COPPER GATE ADDITION

Re: S/D 98-41 -- One-Step Final Plat of COPPER GATE ADDITION

STAFF REPORT

CASE NUMBER: S/D 98-41 - COPPER GATE ADDITION

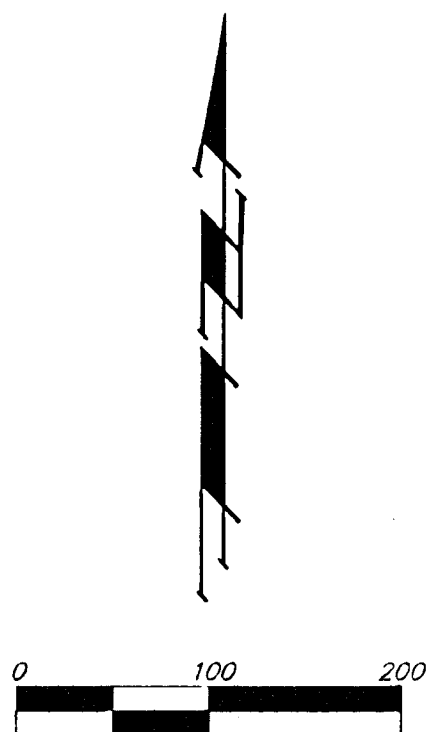
- A. City Engineering needs to indicate the need for guarantees or easements. *Guarantees for future sewer and water extension will be needed. Per the CUP, the site cannot be developed until municipal water and sanitary sewer are available.*

- C. County Engineering needs to comment on the status of the applicant's drainage plan. *The drainage plan needs to be approved.*
- D. Traffic Engineering needs to comment on the acceptability of the access controls. In regards to the southern tract, the plat denotes three openings along 135th St. West - a joint opening between lots 1 and 2, one opening for lot 1, and one opening for lot 3 in accordance with the CUP. Also for the southern tract, the plat denotes two openings along 13th St. North, both located within lot 1 and complete access control along lot 3; whereas the CUP permitted one opening for lots 1 and 3. A CUP adjustment will be needed if this revision is approved. *Regarding the southern tract, Traffic Engineering requires 175 feet of complete access control along the eastern boundary of Lot 3. The three permitted openings along 135th St. must be separated by a minimum of 200 feet. Along 13th St. North, two joint openings along the northern tract (between Lots 1 and 4, and between lots 4 and 2) will line up north and south with openings along the southern tract.*

In regards to the northern tract, the plat denotes three openings along 135th St. West - two openings for lot 4, and a joint access between lots 2 and 3, in accordance with the CUP. Also for the northern tract, the plat denotes two openings along 13th St. North for Lot 4,

with complete access control along lots 1 and 2; whereas the CUP required both of these openings to be joint accesses. Cross-lot access agreements and a CUP adjustment will be needed if this revision is approved.

- E. The joint access openings will need to be established by separate instrument. Initial construction responsibilities and future maintenance of the driveways within the easements should also be addressed by the text of the instrument.

- F. In regards to street improvements, the CUP required guarantees for 135th Street West and 13th Street North for improvement to three lanes from major openings to the intersection and two lanes beyond along the frontage. The CUP also required guarantees for 135th St. West and 13th St. North for the installation of acceleration and deceleration lanes.

- G. Per the CUP, a cross-lot circulation agreement will be needed to insure vehicular circulation between all lots.
- H. A CUP Certificate shall be submitted to MAPD for recording with the Register of Deeds prior to City Council consideration, identifying the approved CUP (referred as DP-231) and its special conditions for development on this property.

- P. The representatives from the utility companies should be prepared to comment on the need for any additional utility easements to be platted on this property. **Southwestern Bell requests additional easements.**

- D. **Regarding the southern tract, Traffic Engineering requires 160 feet of complete access control along the eastern boundary of Lot 3. The three permitted openings along 135th St. must be separated by a minimum of 200 feet. Along 13th St. North, two joint openings along the northern tract will line up north and south with openings along the southern tract. There shall be 175 feet of critical access control on both the north and south sides of 13th Street, from 135th Street West. Critical Access Control should be provided from a point 243 feet west of 135th Street to a point 431 feet west of 135th Street.**

In regards to the northern tract, the plat denotes three openings along 135th St. West - two openings for lot 4, and a joint access between lots 2 and 3, in accordance with the CUP. Cross-lot access agreements and a CUP adjustment will be needed if this revision is approved.
